REMARKS

Figures 1, 2, 4, 5, and 8 have been amended, and the changes shown in red ink on one set of the accompanying drawing sheets.

Version to
Show
Changes

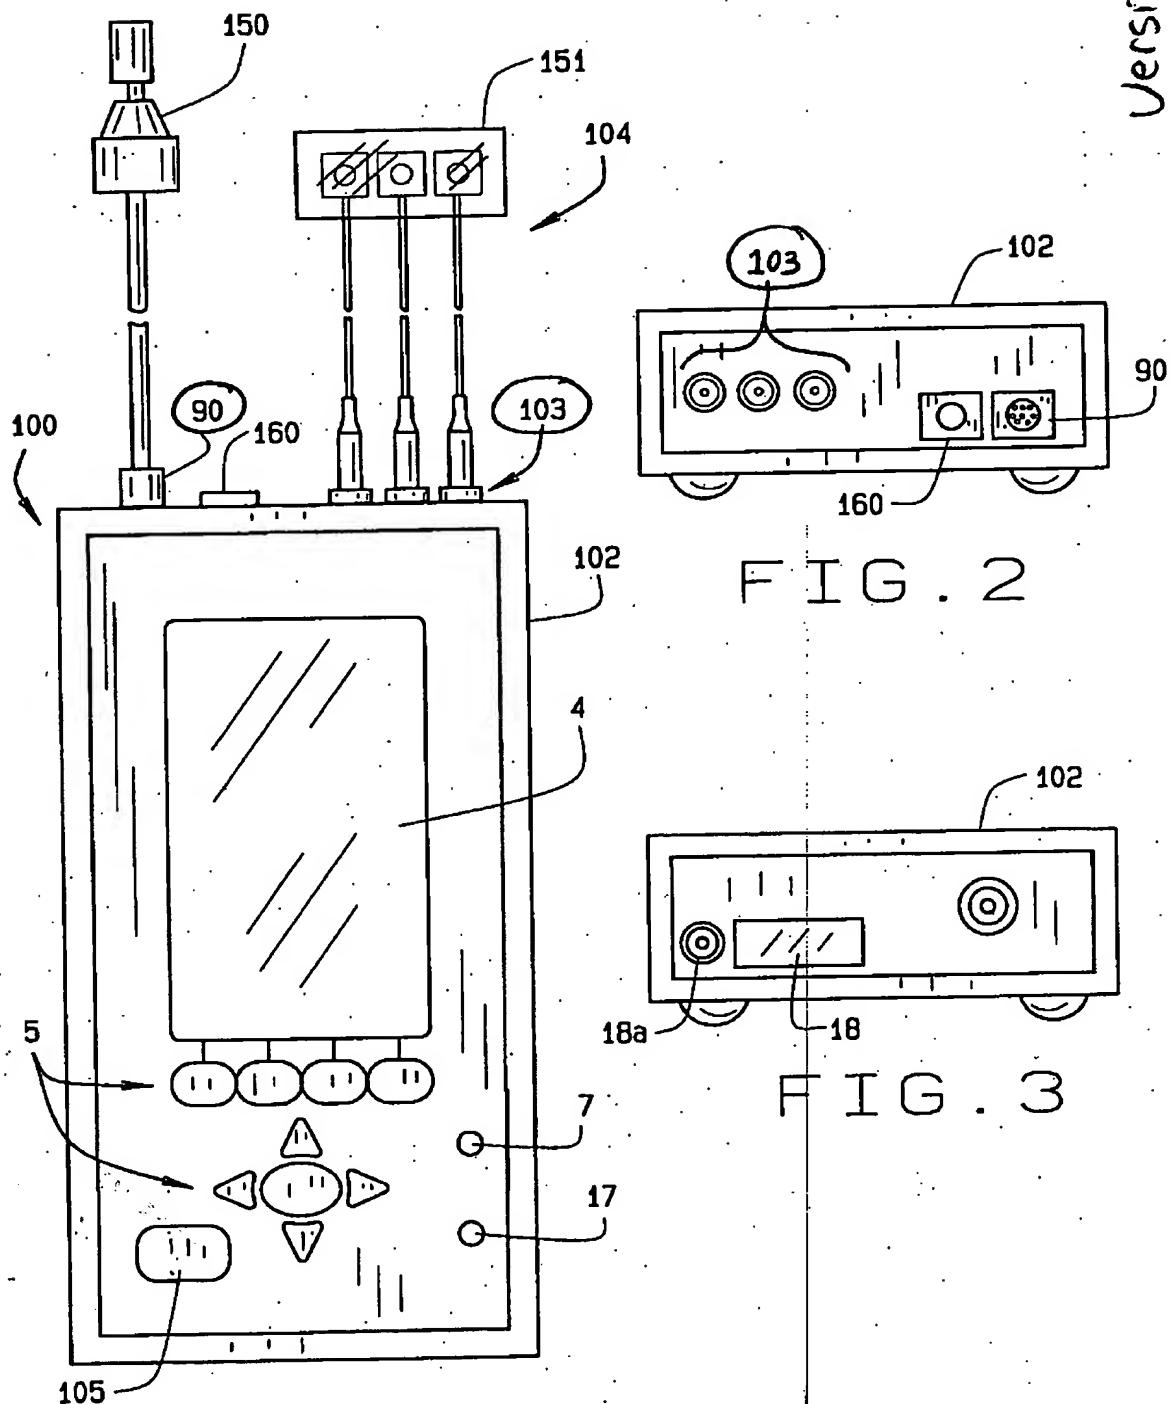
In Figure 1, reference numeral "9" has been changed to reference numeral "90" as indicated, corresponding to the changes to the Specification at Page 6, set forth in the accompanying Amendment B document. Reference numeral "103" has been added to identify the "interface 103" described in the specification at Page 6.

In Figure 2, reference numeral "103" has been added to identify the "interface 103" described in the specification at Page 6.

FIG. 4

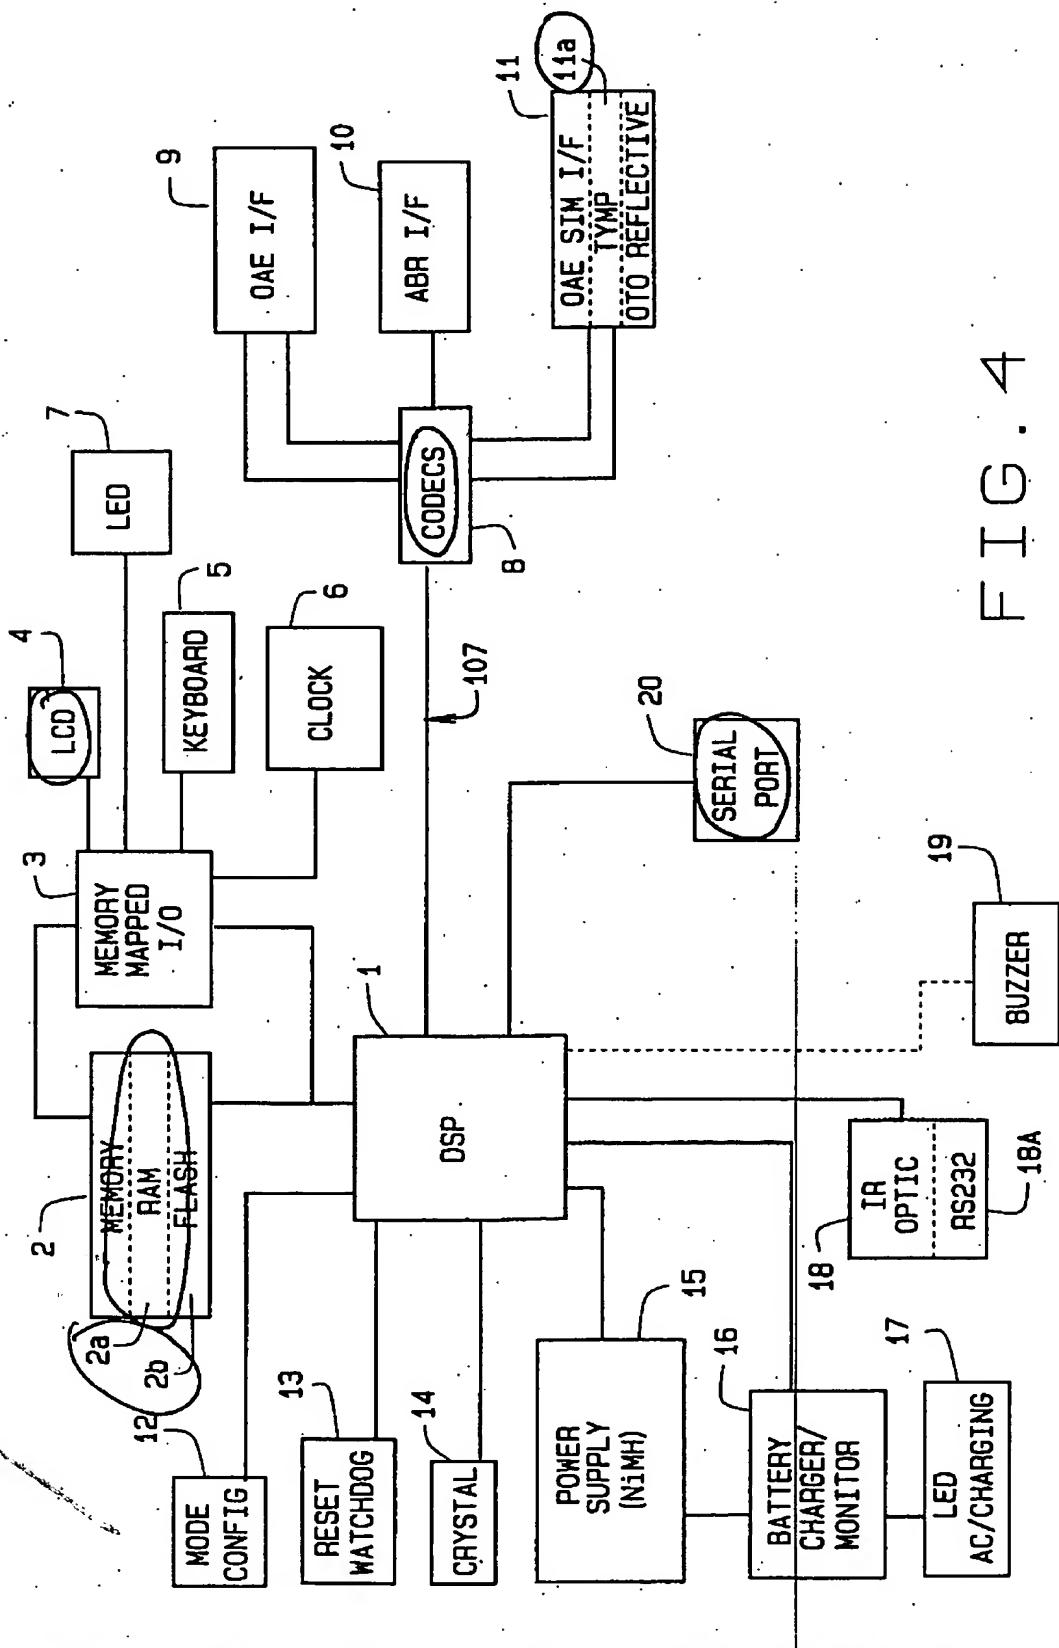
In Figure 4, reference numerals "2a" and 2b" have been added to identify the "random access memory (RAM) 2a" and the "flash memory 2b" described in the Specification at Page 7, lines 22-26. Reference numeral "11a" has been added to identify the "tympanometry interface 11a" described in the Specification at Page 9, line 32. Reference numeral "107" has been added to identify the "dedicated serial link" described in the Specification at Page 8, lines 20-22. The label "LLD" associated with reference numeral "4" in Figure 4 has been corrected to read "LCD". Similarly, the label "JTAG/ONCE" associated reference numeral "20" has been corrected to read "SERIAL PORT", and the label "CODE CS" associated with reference numeral "8" has been corrected to read "CODECS".

FIG. 5

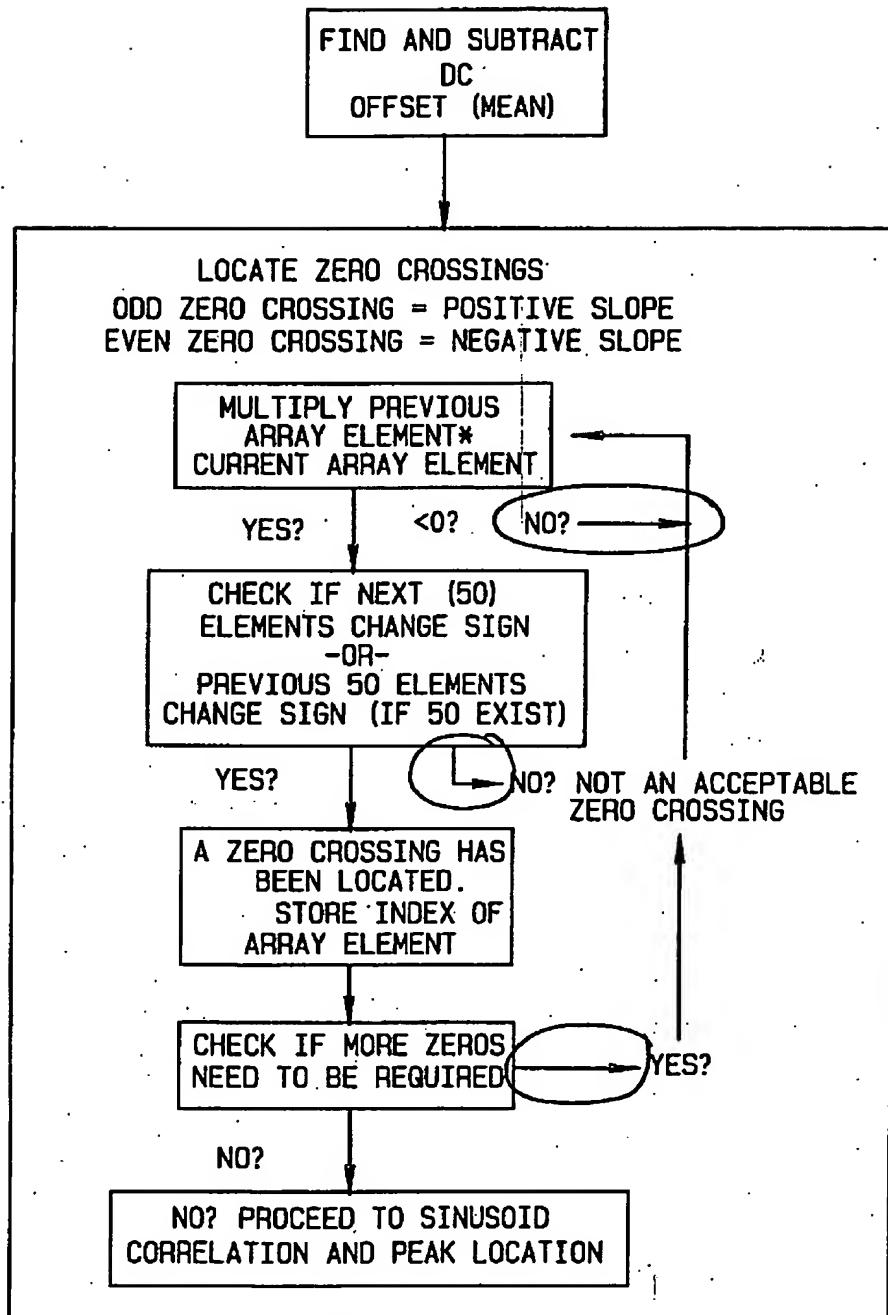
In Figure 5, three connecting arrows have been added indicating the process directions for "NO" at the first and second boxes, and the "YES" process direction at the fourth box.

FIG. 8

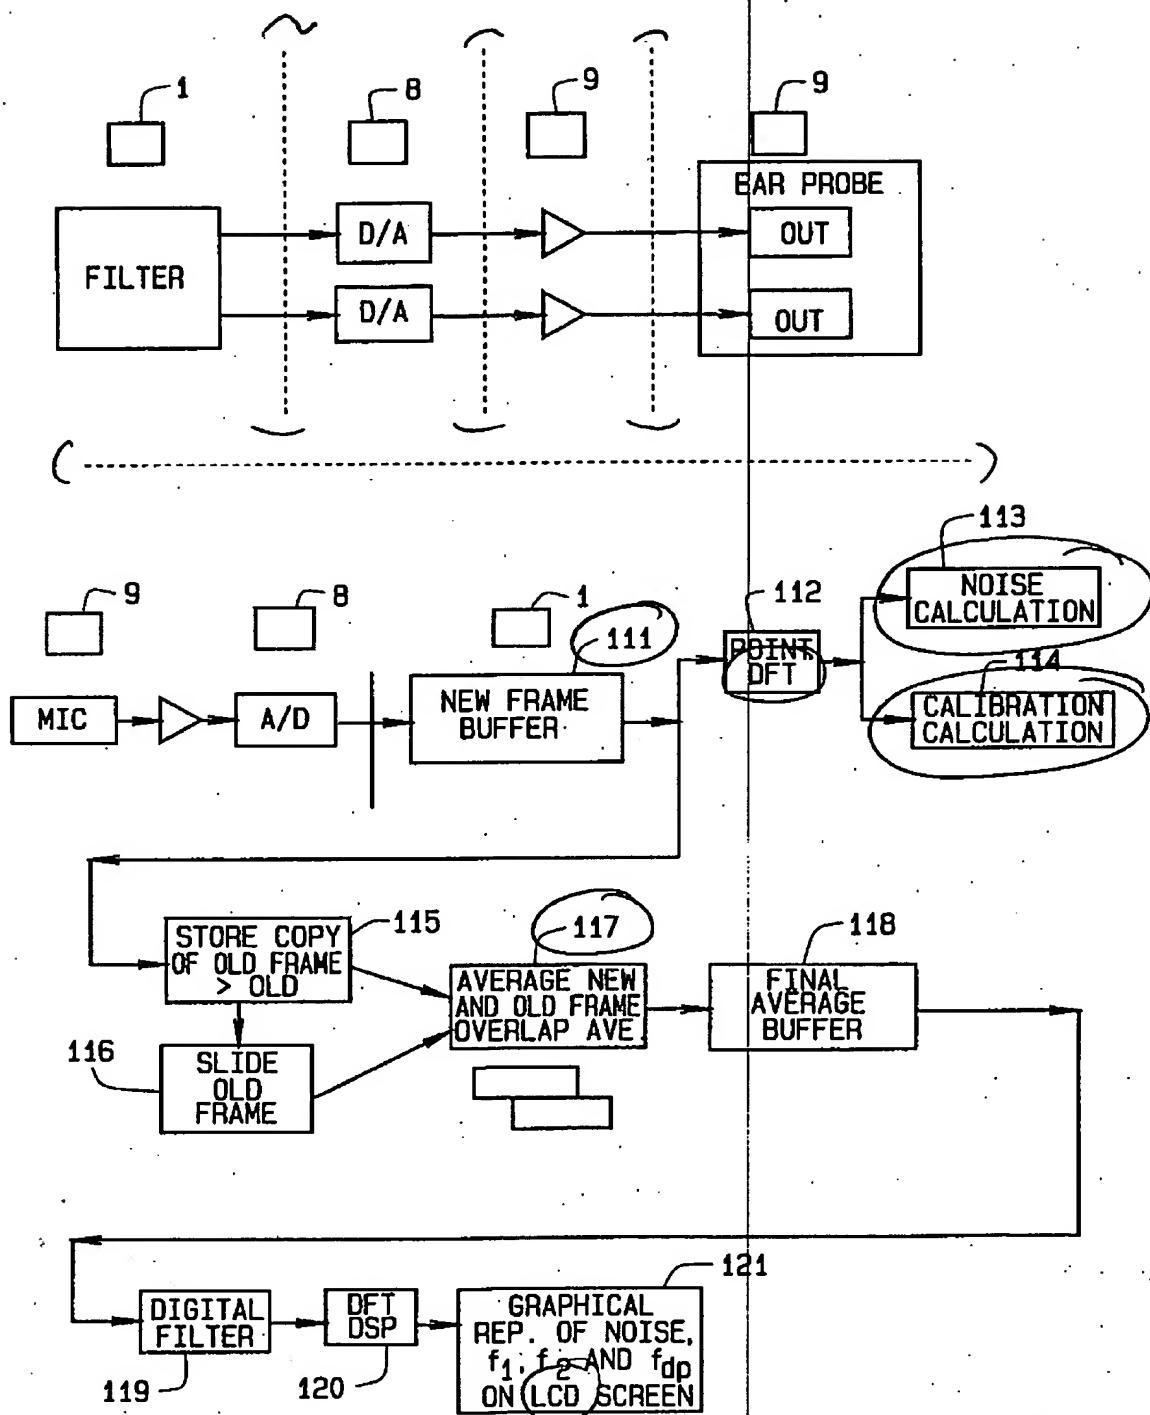
In Figure 8, dashed lines have been added to better distinguish which parts of the operational sequence are taking place within discrete components of the auditory testing device of the present invention. Reference numeral "110" has been corrected to reference numeral "111". Similarly, the second occurrence of reference numeral "114" appearing at the box labeled "Average New and Old Frame Overlap Ave." has been corrected to reference numeral "117". Abbreviated descriptions in boxes 113 and 114 have been expanded. The term "OFF" appearing in box 112 has been corrected to "DFT", and term "LED" appearing in box 121 has been corrected to "LCD".
